Community Solar Project Interconnection  
**Tier 2 Community Solar Project Review**

**(Applicant)**  
**OCS003**

Proposed Interconnection  
**On PacifiCorp's Existing**  
**Circuit 5L26 out of Merrill substation**

**May 18, 2020**

Figure 1: System One Line Diagram

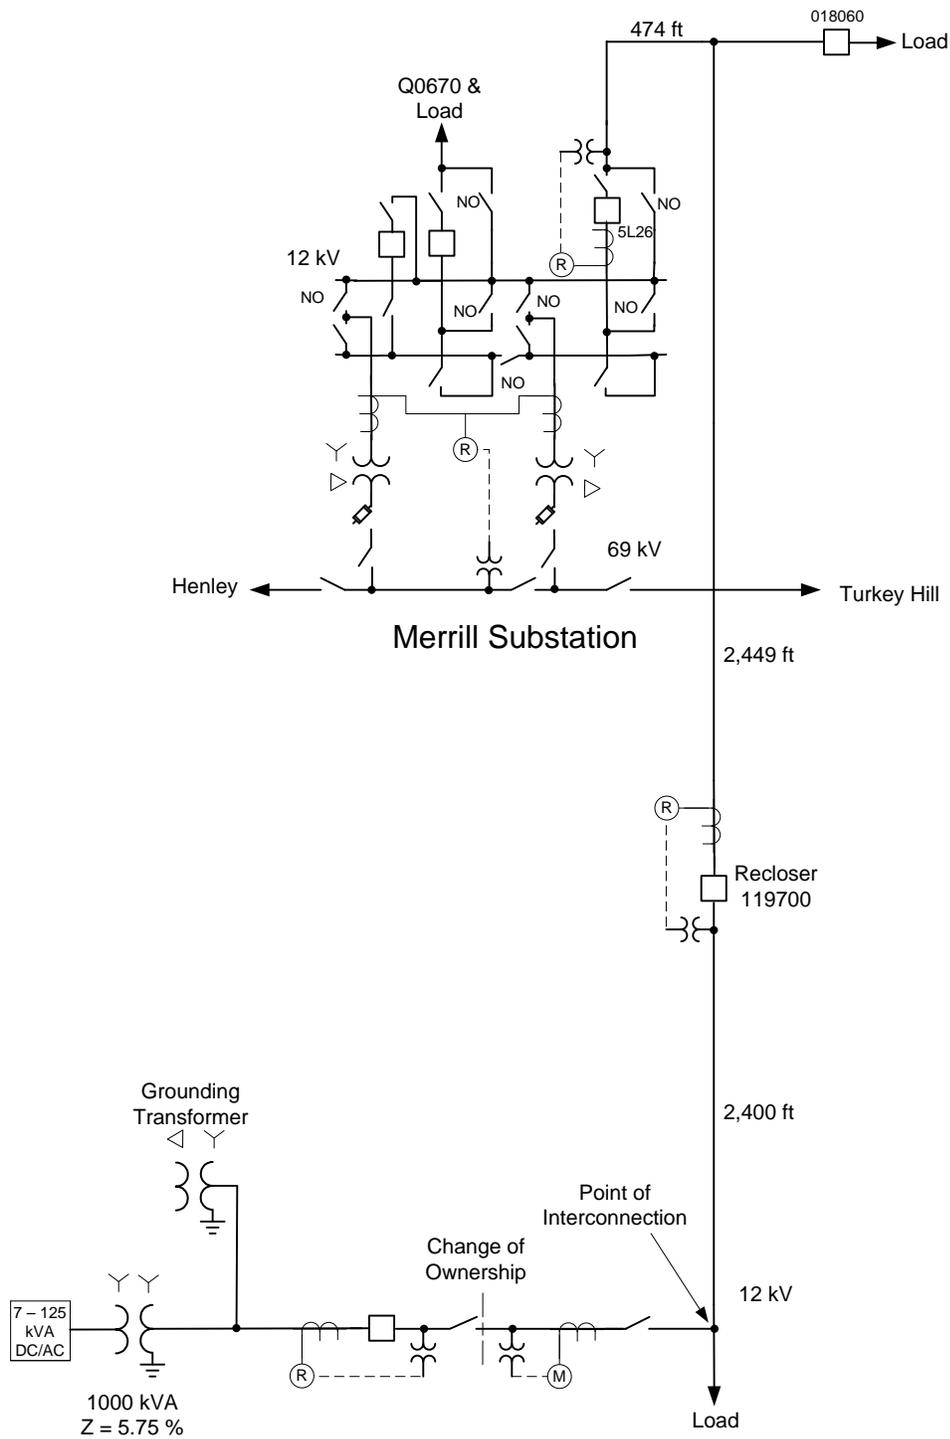
The proposed Community Solar Project is to be interconnected to the Public Utility’s 12 kV circuit 5L26 out of Merrill substation.

OCS003 will connect to a three-phase, four-wire primary line and will require a grounding bank to meet the effectively grounded requirement.

The line recloser 119700 will need to be replaced with a unit that has a relay/controller that can communicate with the interconnection relay at the solar site. This recloser will also be equipped with voltage instrument transformers so that the relay can sense if line to the solar site is energized. An optical fiber cable will need to be install on the distribution line between the line recloser 119700 and the solar site. This is a length of approximately 2400 feet.
